# Planning and Zoning Commission STAFF REPORT

**MEETING DATE:** February 6, 2014

1. DSA-13-00158: Major Site Plan to construct a 21,030 Sq. Ft. manufacturing/warehouse building addition and a new parking lot on the Hexcel Corporation Manufacturing 4.24 acre site located at 1214 W Gila Bend Hwy.

**L-101**  
 PRELIMINARY LANDSCAPE PLAN

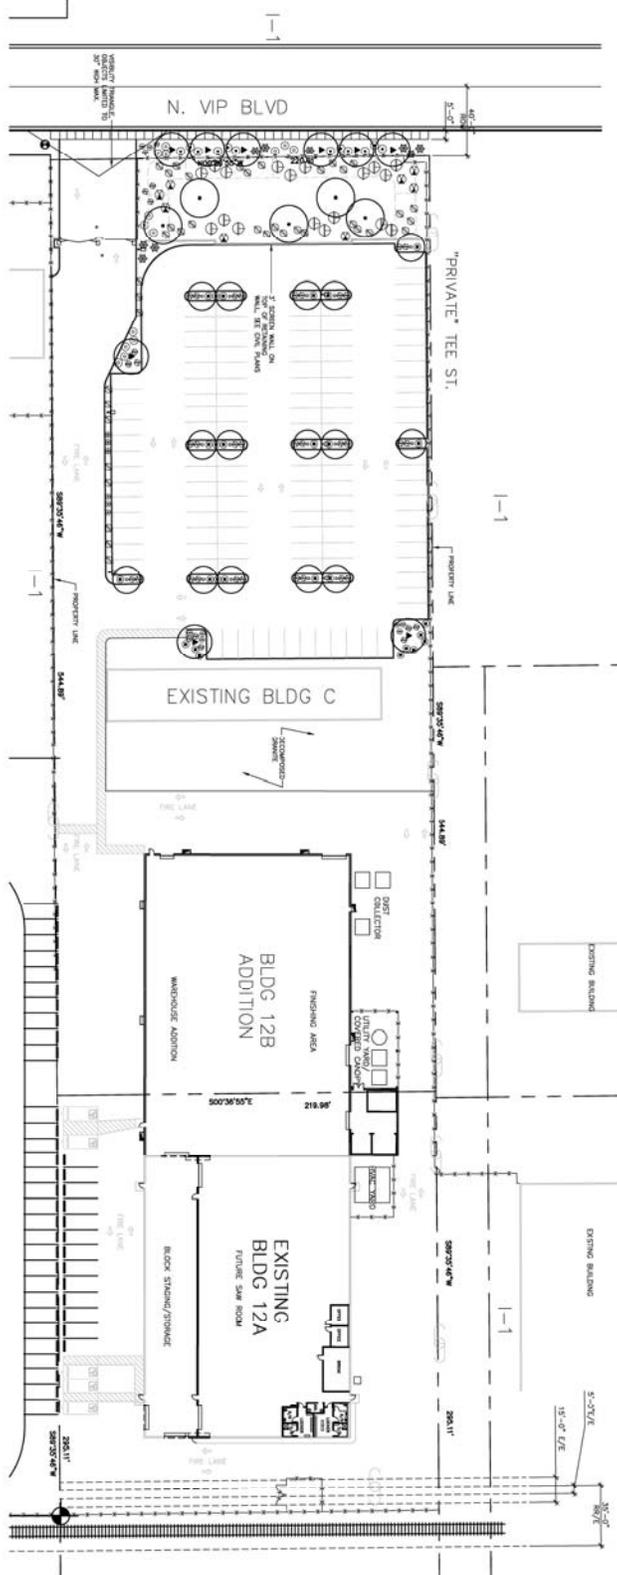
Landscape Plan (L-101):

1. Revise the project Code Data Table to match the requested revisions for the Site Plan (AS-110).
2. Provide four (4) additional trees in the on-site area.
3. Revise the total # of required on-site shrubs in the Project Code Data Table to 80.
4. Revise the site visibility triangle and landscaping to comply with the City of Casa Grande Engineering Division Minimum Site Distance Requirements dated April 2001.
5. Delete all interior floor plan details from building 12A.

**CONCEPTUAL GRADING AND DRAINAGE PLAN FOR  
HEXCEL CORPORATION PARKING LOT  
NEC VIP BLVD & WEST GILA BEND HWY  
CASA GRANDE, ARIZONA**

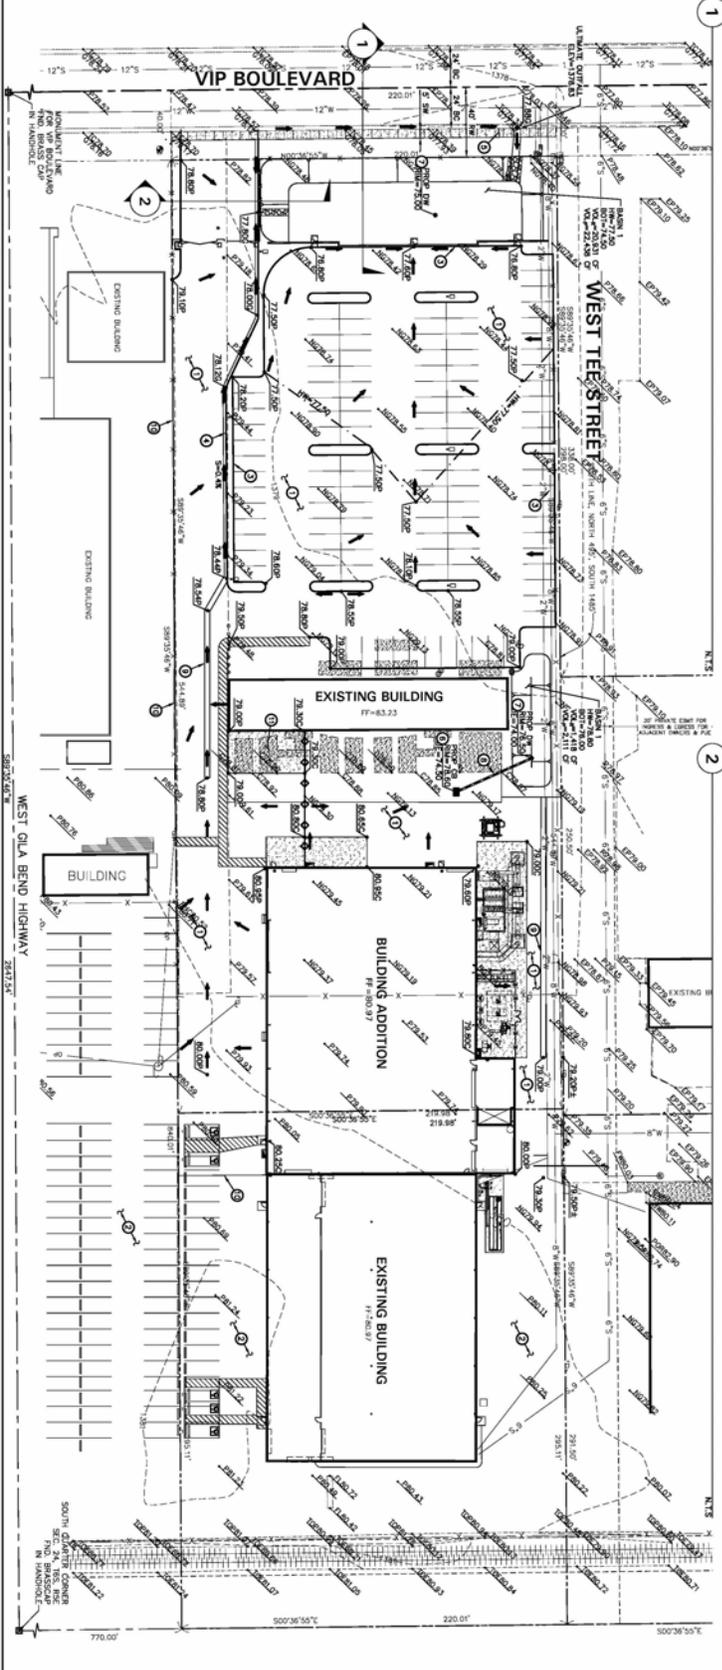
**2) The Major Site Plan shall be revised to reflect the following Engineering technical corrections:**

- a. Provide the details of call outs shown on the conceptual grading and drainage plan.
- b. Provide a grading and drainage plan for the existing building and building addition (15.40.520) along with hydrological and hydraulic calculations.

- c. Provide hydrological peak flows calculations used for the proposed curb openings sizing.
- d. Revise the drainage design and provide hydrologic and hydraulic calculations to include all water which falls within the respective one-half of all abutting streets (Including W Tee Street) to the development from a 100-year storm event of a 1-hour duration as it must be retained within the boundaries of the development (15.40.1240A, 15.40.1250A, 702.1).

- e. Size the site retention basins for the developed stormwater flows generated from the whole site (15.40.520) with runoff coefficients established in the City code 15.40.1290 to meet the code requirements. Weighted runoff coefficient may be estimated and can be used for calculations. Retention basin for area BA2 shall also be provided.

- f. Revise the run off coefficients for pavement area per City Code Section 15.40.1290. The run off coefficient of 0.9 proposed is inconsistent with the City code required 0.95 for pavement area. Weighted runoff coefficient may be calculated and used for calculations.

- g. Clarify the retention volume over the "PARKING LOT". Also show the limits of retained storm water with maximum water depths.
- h. Provide a Retention Basin Drainage Easement along VIP Blvd.: Retention basins shall be protected from further development by a recorded drainage easement (15.40.1240.D, 702.1.4)

- i. Provide retention basin bleed off calculations. All the retention basins must drain within 36-hours with and/or without drywells. A shallow pit

percolation tests shall be performed in retention areas to determine natural percolation. Test results shall be submitted to the city engineer prior to approval of drainage plans (15.40.1290.C).

- j. Indicate the responsible party in the drainage report for the maintenance of the retention basin for onsite and offsite volumes.
- k. Include headloss coefficient(s) for required backflow prevention devices for modeling of fireline(s).

- l. Provide further documentation of type II-B construction
- m. Confirm fire demand with Fire Marshall – particularly assumptions made for square footage and deduction for fire sprinklers. Total square footage needs to be accounted for in calculation of fire-demand unless otherwise approved by the Fire Marshal.

- n. Perform shallow pit percolation tests in retention areas to determine natural percolation. Please provide the bleed off calculations of the retention basin in conformance with the standard for disposal of the total ponding volume within 36 hours. Please indicate if the drywell is required. (Ch 15.40.1290).

- o. Provide hydraulic (weir) calculations from retention basin (1) by allowing it to spill out to the storm water outfall (over topping West Tee Street). Please indicate if the outfall will be maintained in post development condition. A drainage easement maybe required to provide proper passage of this flow across W. Tee Street.

- p. Show the elevation of the ultimate outfall.
- q. Show pavement (thickness) cross section of the parking lot.
- r. Label the proposed concrete curb/gutter & sidewalk into MAG Std Detail #

- s. Identify the new sewer lines.
- t. All Engineering aspects are subject to the resolution and satisfaction of the City Engineer, of issues raised in the course of the technical reviews of plans, plats, &/or reports associated with this submittal by the City Engineer, the Public Works Engineering W/WW & Drainage specialists, the City Traffic Engineer, and the Development Center Review Engineer.
